RECORD OF DECISION

Monroe Electronics
State Superfund Project
Lyndonville, Orleans County
Site No. 837013
March 2016

Prepared by
Division of Environmental Remediation
New York State Department of Environmental Conservation

| DRAWING TITLE: ALTERNATIVE 3: FOCUSED BEDROCK AQUIFER EISB AND ISCR INJECTION POINTS |

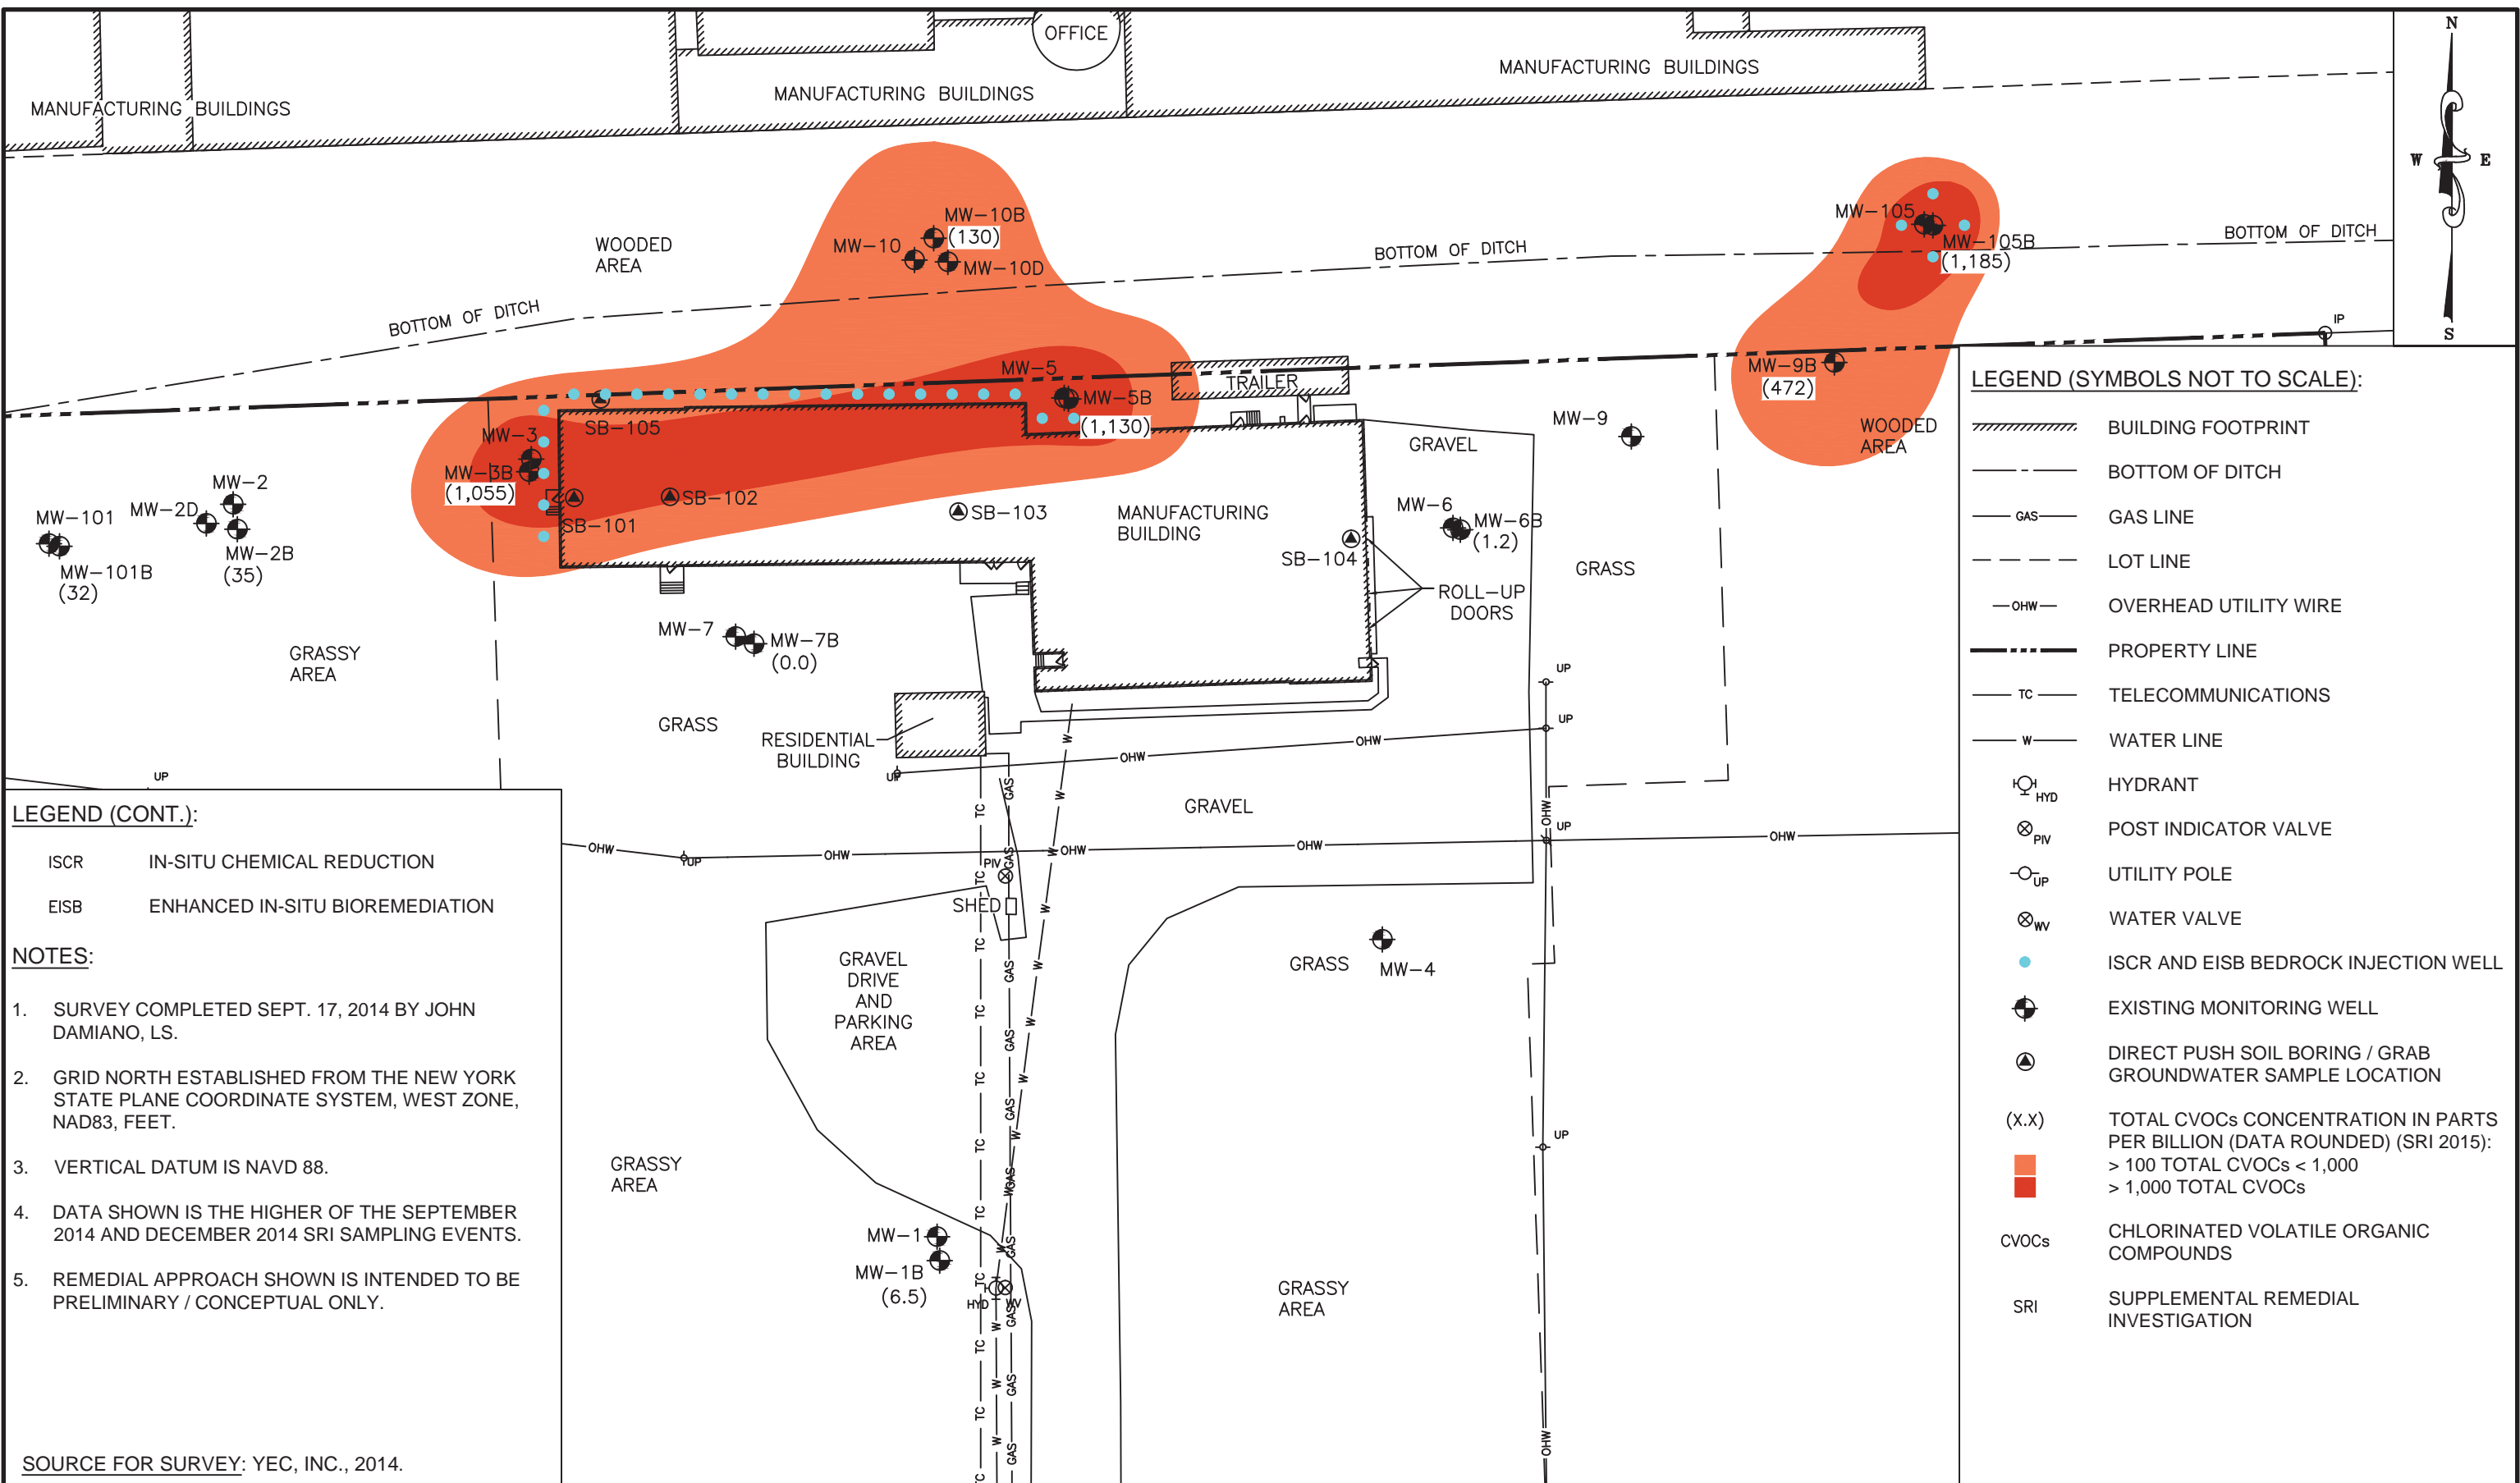
COMMENT 16: Bowman is concerned that the treatment proposed by Alternative 3 is too limited in area. There do not appear to have been any bedrock groundwater monitoring wells installed

between the two areas delineated for remediation on Figure 7 of the PRAP north and northeast of the Monroe Electronics manufacturing building; these areas appear to be approximately 200+ feet apart. The only bedrock groundwater monitoring well in this vicinity is MW-6B, which is due east of the manufacturing building and south of the two proposed remedial areas. Thus, the bedrock groundwater may be elevated in this intervening area, in which no monitoring wells were placed. Accordingly, it is recommended that several additional monitoring wells be installed between the two areas slated for remediation and, if the levels are elevated, the remedial approach should be applied to those areas as well. In that regard, the 1,000 ppb trigger is too low and should be in the 400-500 ppb range to maximize effectiveness of the remediation. For that reason, Bowman requests that ISCR and EISB injections should be added in the vicinity of MW-9B, to assure that TVOCs present in the bedrock groundwater in that area are remediated.

RESPONSE 16: Further characterization of CVOC contamination in the bedrock will be completed as part of the remedial design phase. Such characterization may include the addition of new wells including the area between MW-10B and MW-105B.
